Report of the Head of Planning & Enforcement

Address: FORMER NESTLE FACTORY, NESTLES AVENUE

LBH Ref Nos: 1331/APP/2017/1883

Figure 4: Strategic design principles for emerging Hillingdon site allocation SA5.

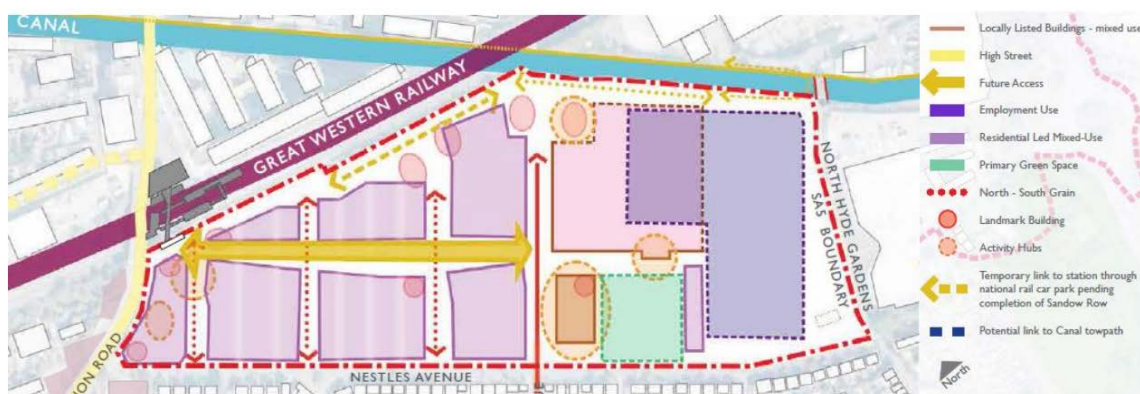
41 The masterplan in figure 4 essentially seeks to establish a new east-west route into the heart of the site, connecting the historic Nestle factory core with the station and high street. The canal edge at the north of the site would also be opened up, supporting improved connections with the wider Blue Ribbon Network and Green Chain corridors associated with the Crane Valley to the east. The masterplan seeks to retain the high quality Truscon and Sandow factory building facades, as well as the canteen building and adjacent green space known as Wallis Gardens. In terms of scale, the masterplan envisages taller buildings along the railway, transitioning to low-rise blocks at Nestles Avenue.
